VPNPD-88-497  
NRC-88-094

DOCKET NOS. 50-266 AND 50-301  
OFFSITE DOSI CALCULATION MANUAL (ODCM)  
TAC NOS. M671628 AND M61629  
POINT BEACH NUCLEAR PLANT

ATTACHMENT  
RESPONSES TO ODCM QUESTIONS  
POINT BEACH NUCLEAR PLANT

Figure 2-2

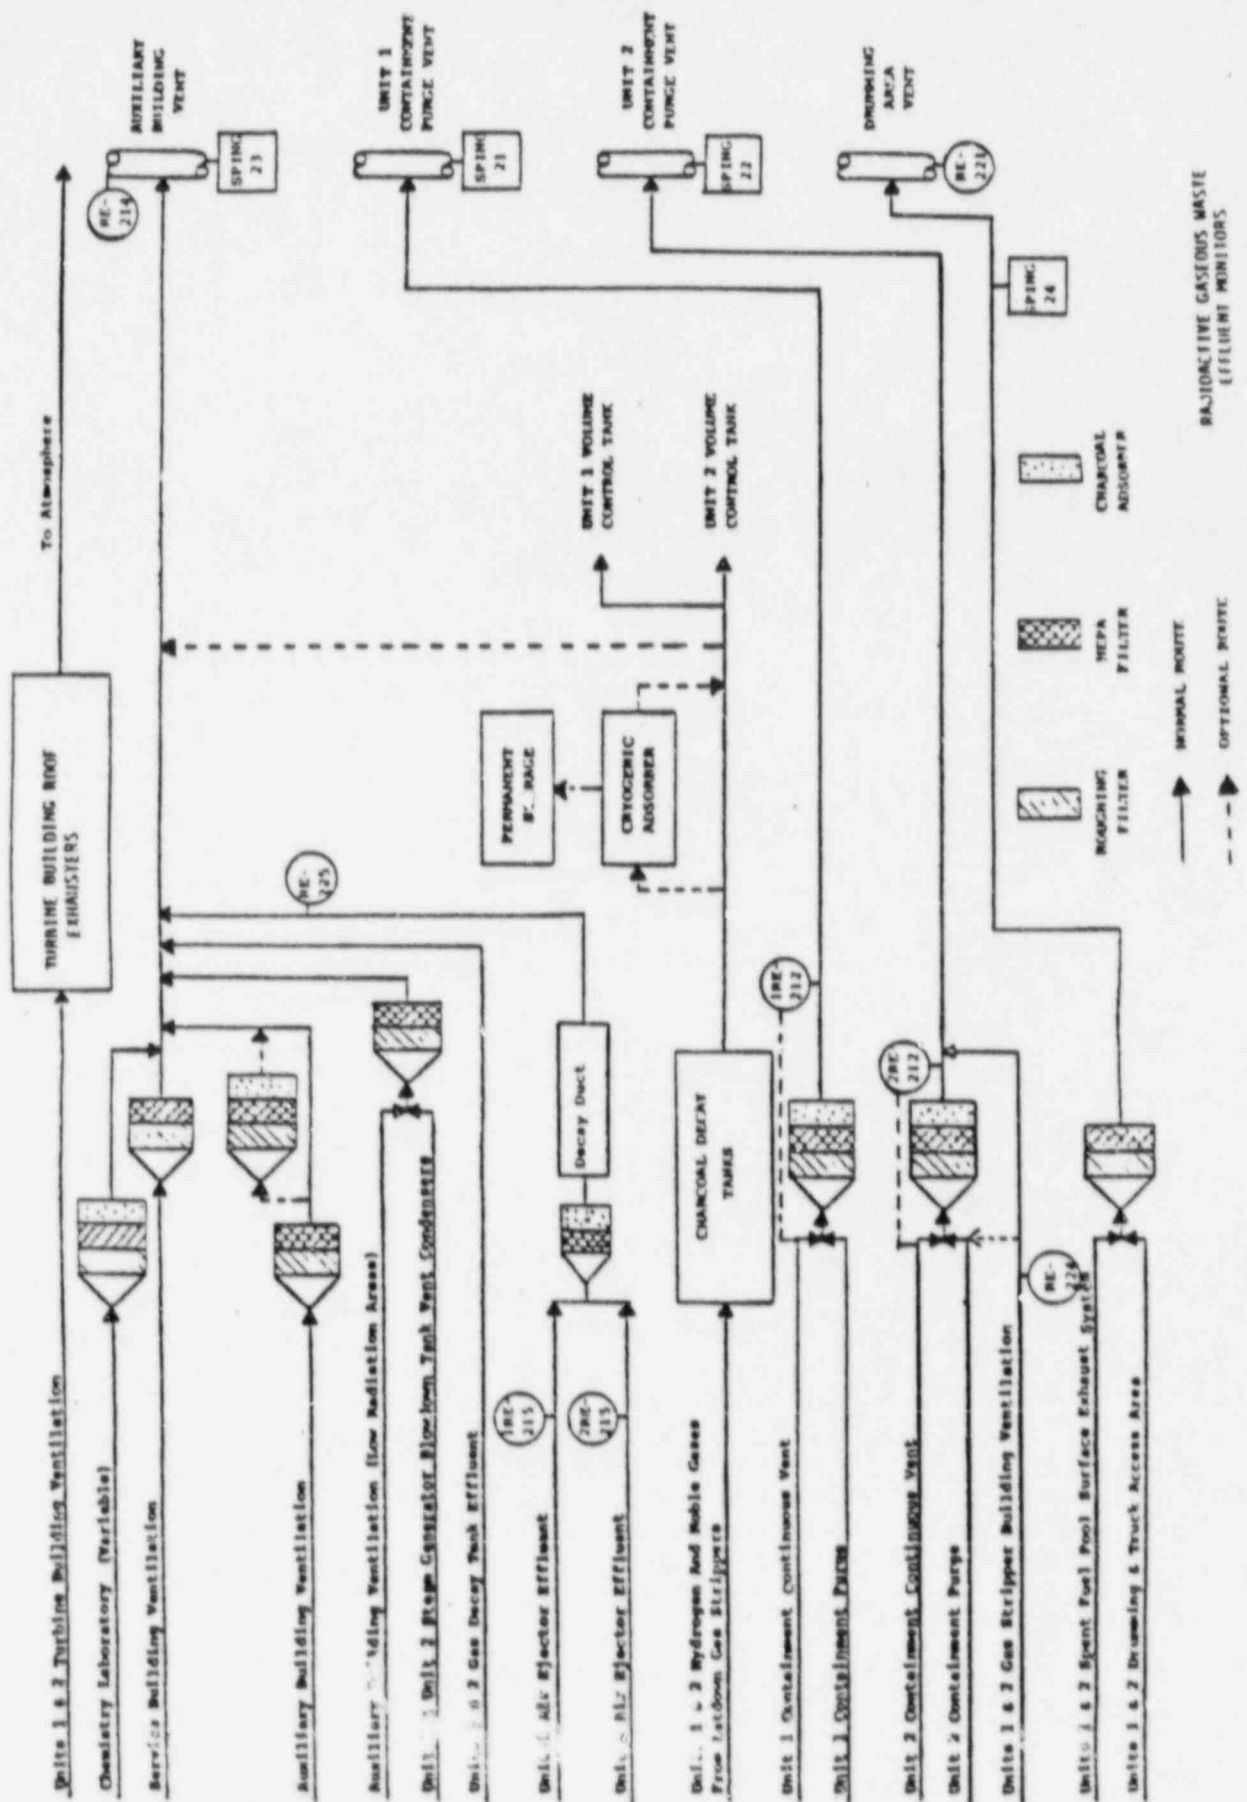
- (12) In Table 5-1, the ratio term for Te-131m should be 1.49E-01 instead of 1.49E-02.
- (13) A simplified diagram for the gaseous waste treatment system is supposed to be in Figure 2-2. However, Figure 2-2 is a repeat of the liquid radwaste treatment system which is shown in Figure 2-1 of the ODCM.

The ratio term to Te-131m in Table 5-1 and the gaseous waste treatment system diagram of Figure 2-2 were corrected in the September 1987 revision to the ODCM. A copy of the correct figure is attached herewith.

We believe your question may have been occasioned, at least in part, by the absence of the correct Figure 2-2 in Revision 0 of the ODCM. We trust the above explanation together with the attached, corrected copy of Figure 2-2 resolves the issue.
